**Eugene School District 4J
ROOSEVELT MIDDLE SCHOOL**
680 East 24th Avenue
Eugene, OR 97405
CIP No. 410.566.001

ADDENDUM NO. 3

This Addendum forms a part of the Contract Documents and modifies the original Bidding Documents dated February 18, 2015 as noted below. Acknowledge receipt of this Addendum in the space provided on the Bid Form. Failure to do so may subject the Bidder to disqualification.

OVERALL SITE PLAN

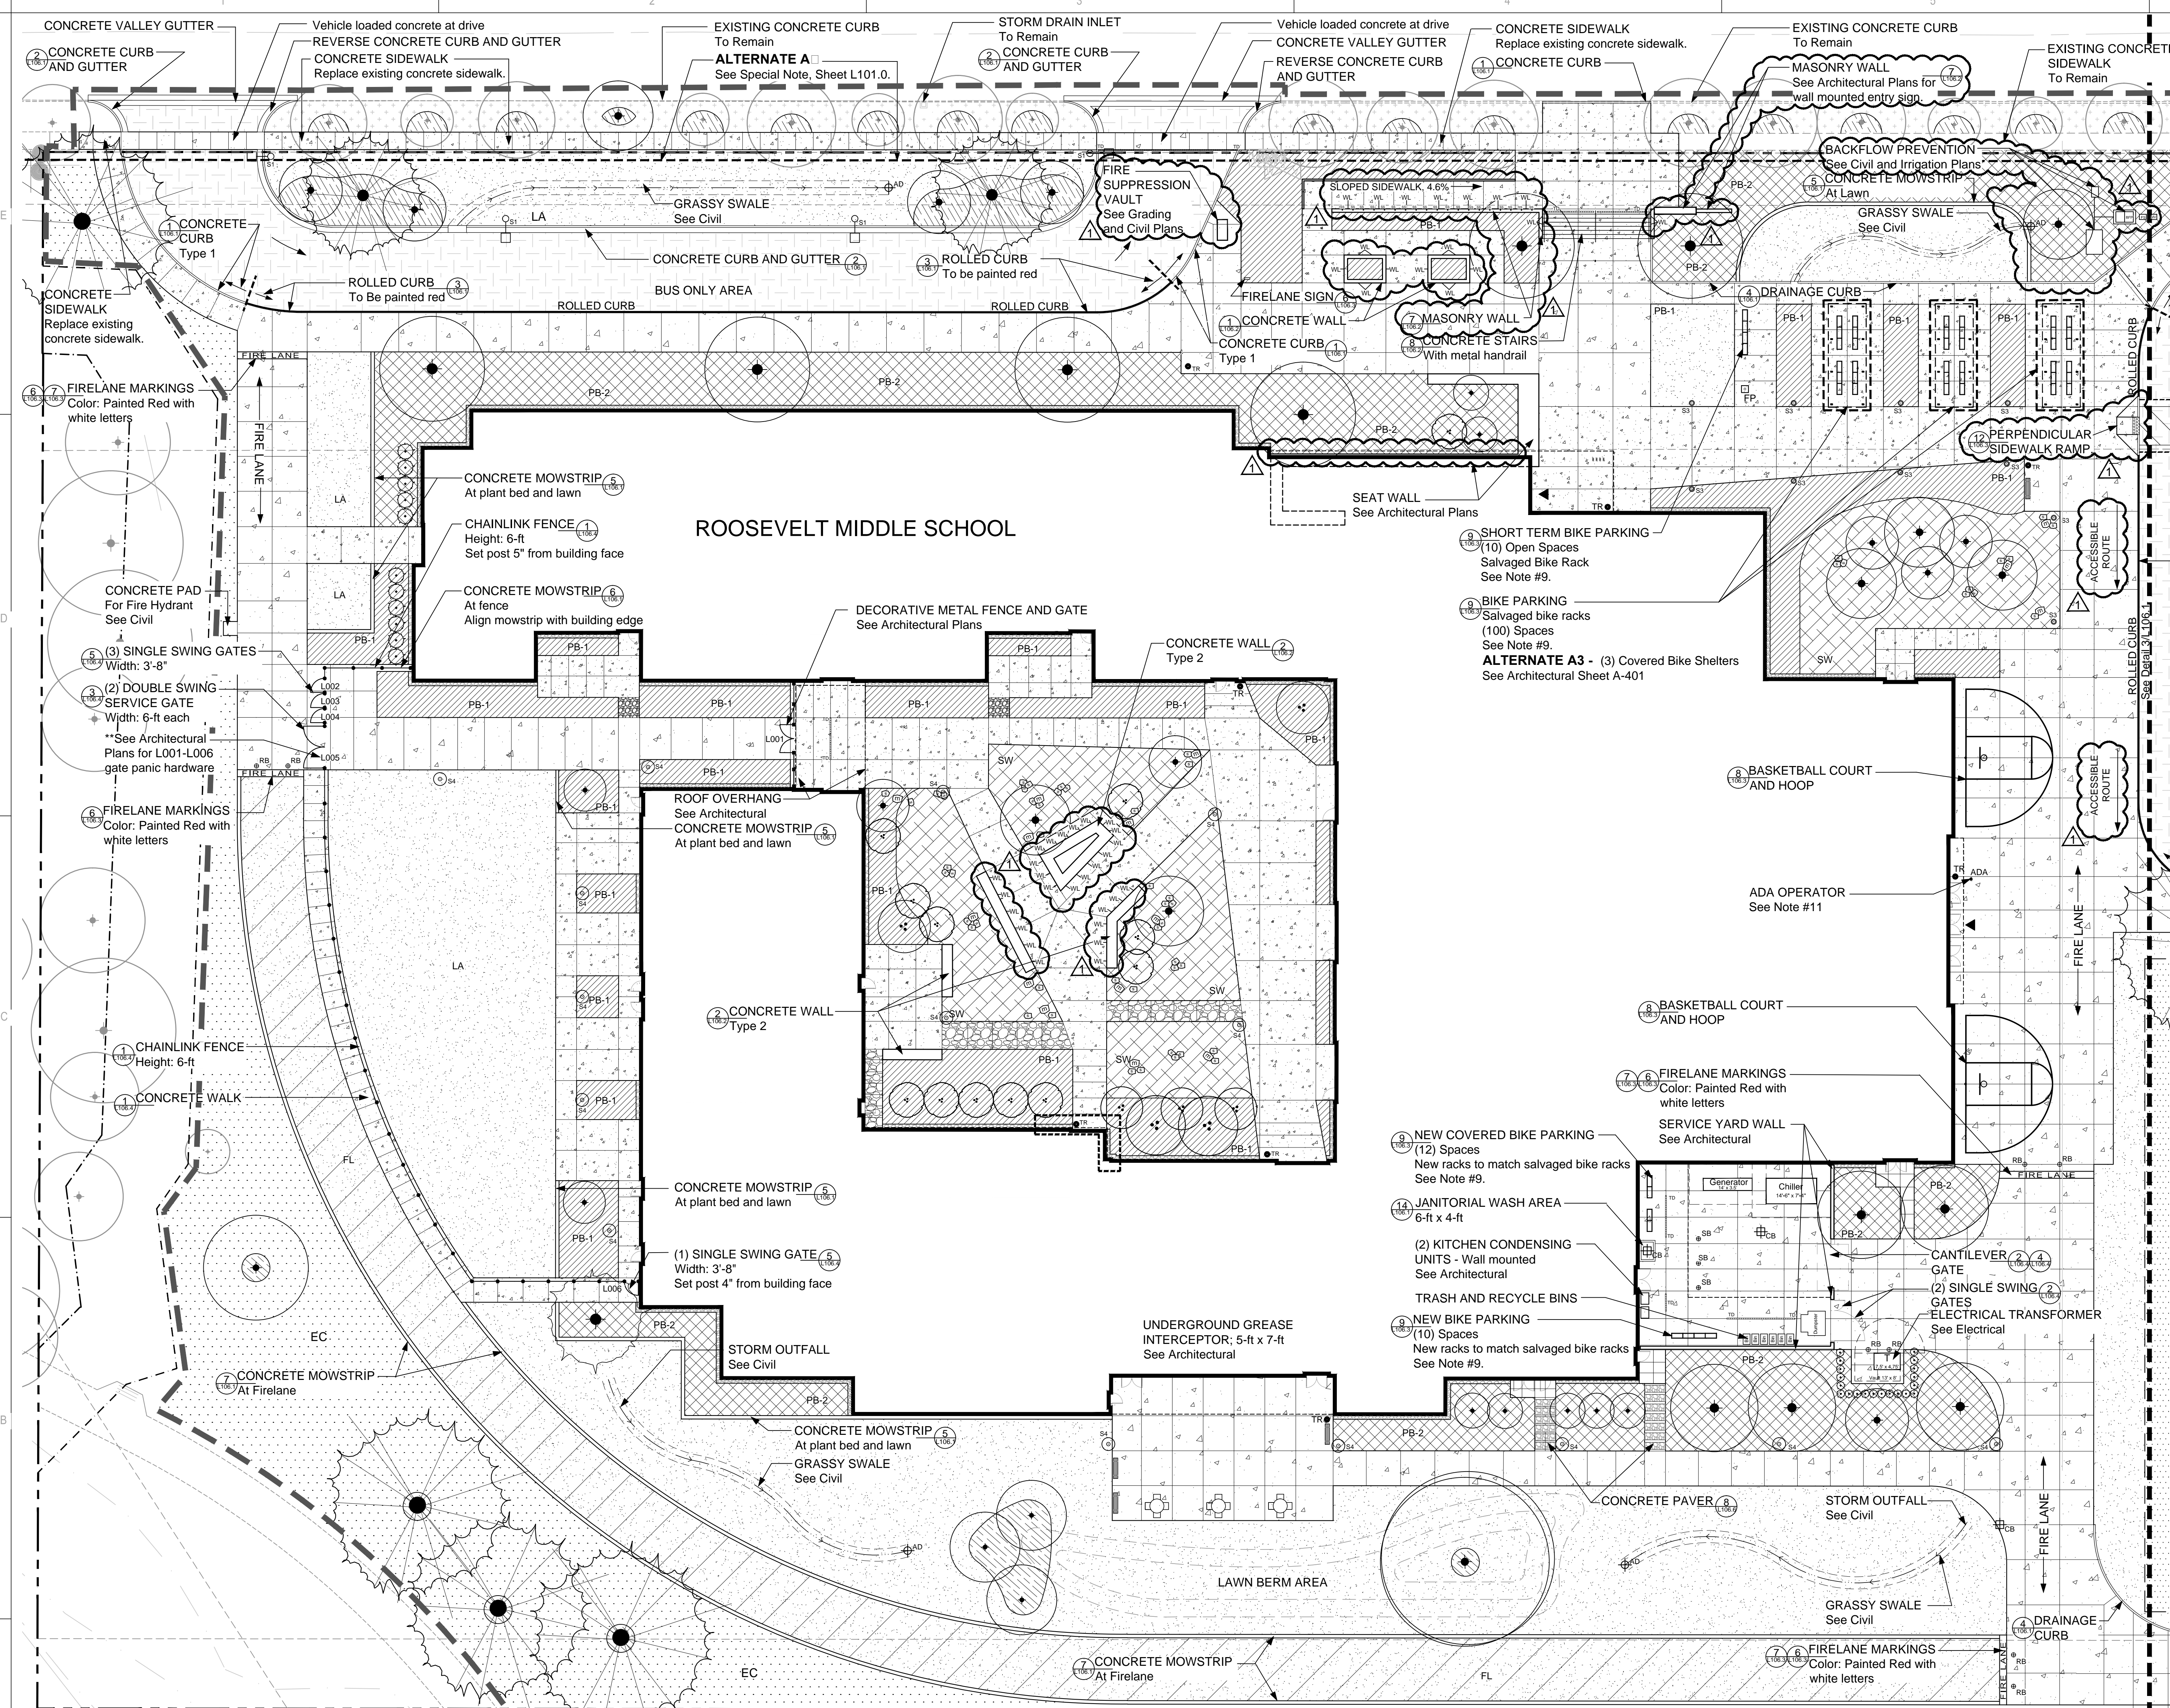
- A. Replace Sheet with attached new Sheet L-101.0. Clarification: Adjusted location of area drain and concrete header at northeast grassy swale. Removed concrete header along northeast building edge. Added electrical pull vault locations and note to plans. Added wall light symbol to drawing and legend. Added bike/skate stop symbol to drawing at entry masonry ramp wall. Changed concrete walls shown to masonry walls at ramp and school sign wall east of stairs. Refer to Architectural Details, Sheet A522. Removed four existing trees, (#49-#52) at island south of existing RMS school for utility work improvements. See Electrical and Civil Sheets. Adjusted perpendicular sidewalk ramp at parking lot.

CENTRAL SITE PLAN

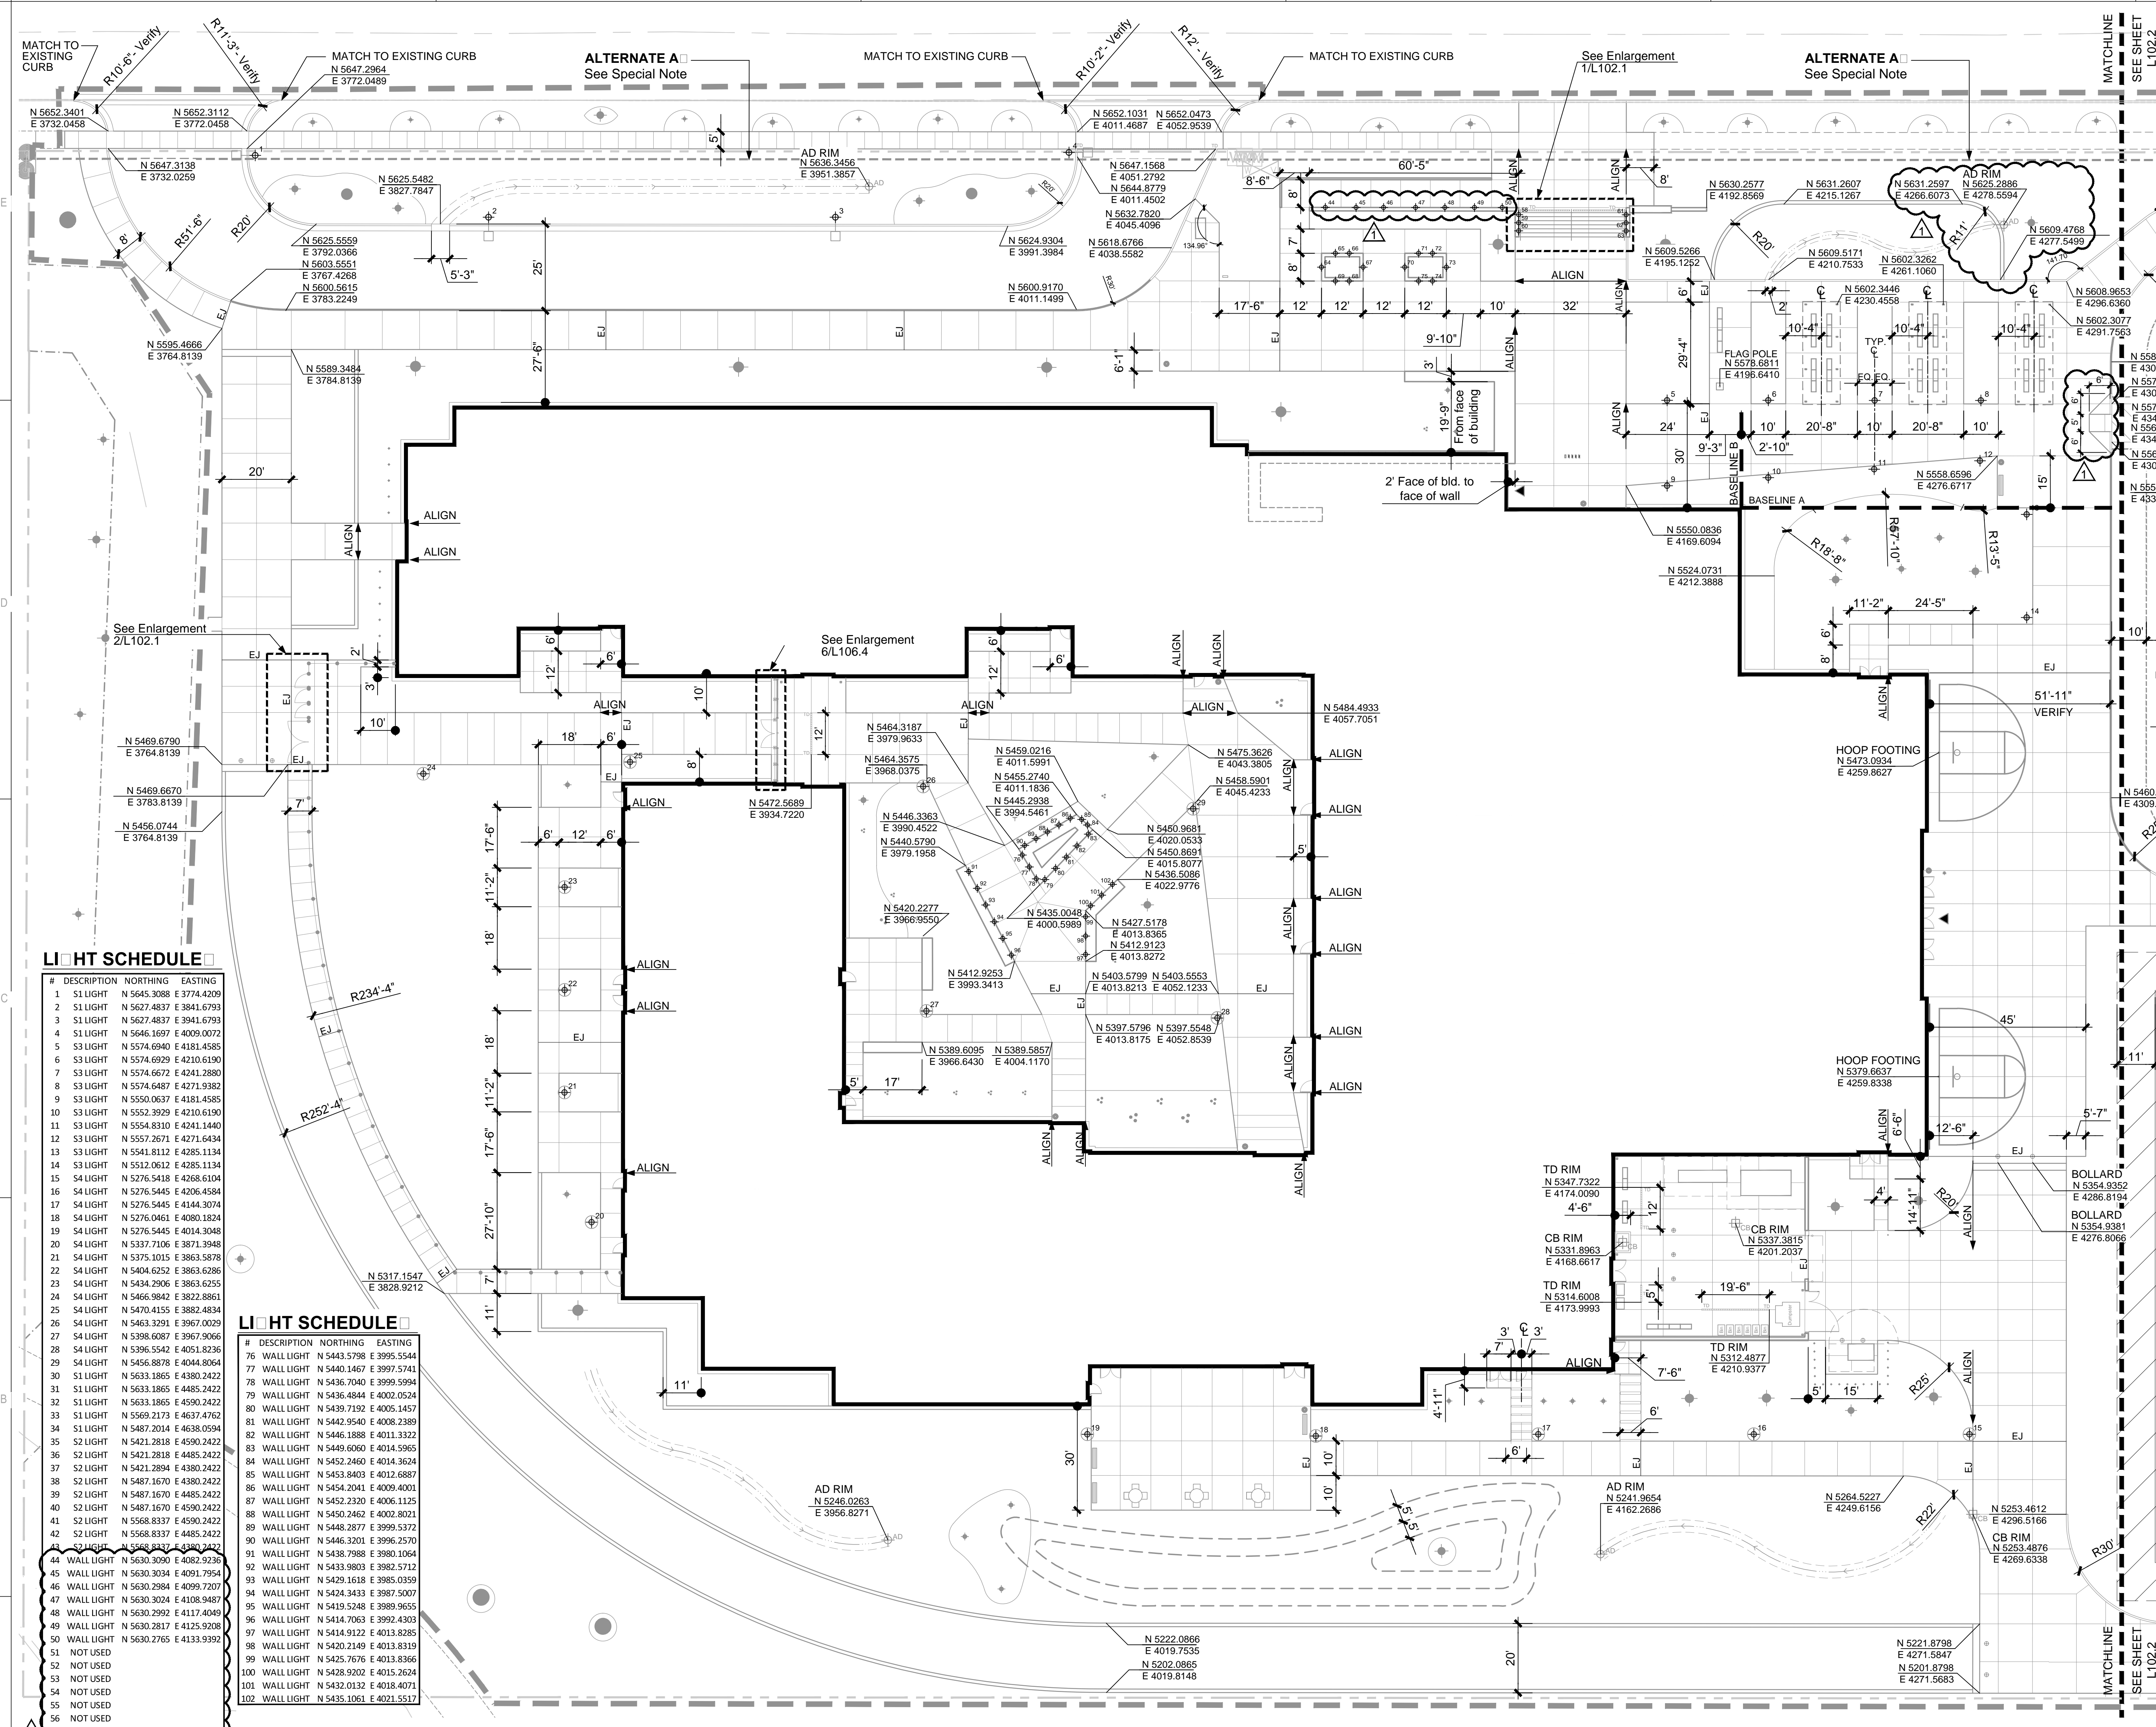
- A. Replace Sheet with attached new Sheet L-101.2. Clarification: Added wall light symbol to drawing and legend. Removed wheel stop detail reference from sheet legend.
